Central Reservoir Replacement Project – Consultants Q&A on 10/3/2023

Summary of Consultant questions and District answers:

Figure 2-5
Cross-Sections of Proposed Site Plan at Ardley Avenue

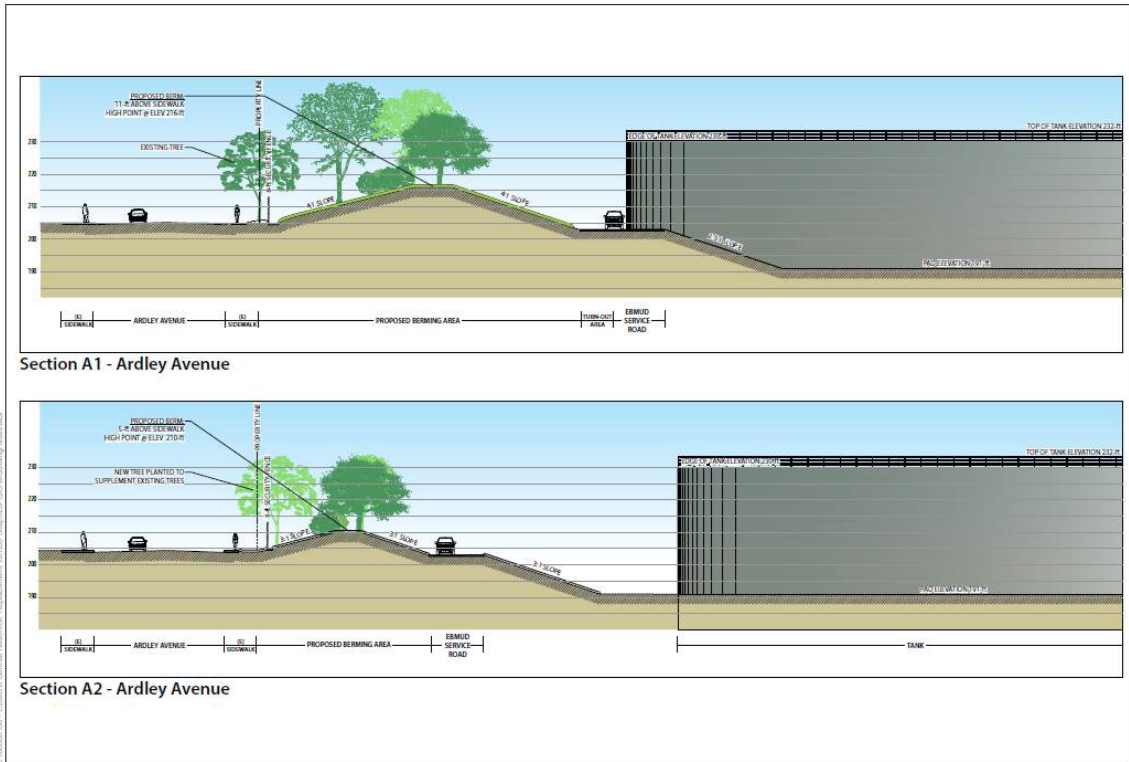
- 47. "Is there a height limit for the new reservoirs? Appears to be driven by hydraulics however, freeboard requirements will drive the final heights of the reservoir. Generally higher than expected."**

See below for Figure 2-5 of the EIR. This figure is also in the architectural design report (Appendix C of the EIR). The max elevation is to be 232 feet in the center (not including the safety railing) and 230 feet at the wall of the tank (not including the safety railing) after accounting for roof slope. The 232 feet elevation accounts for freeboard, roof thickness and roof slope which is why it is 9 feet higher than the overflow elevation of 223 feet and 10 feet higher than the maximum operating level of 223 feet.

The top of the floor of the tanks at the wall must be at the elevation of 183-feet. The tanks will be partially buried such that the elevation of the pad surrounding the tanks will be 191-feet, 8-feet above the tank floor. The elevation of the top of the tank roof will be approximately 230-feet at the outer edge of the tank, increasing to a high point of approximately 232-feet at the center of the tank. The roof will have a 42-inch high guard rail around the perimeter. Typical railing consists of 1.5-inch posts spaced every 5-feet and 6 stainless steel cables spaced approximately every 6-inches.
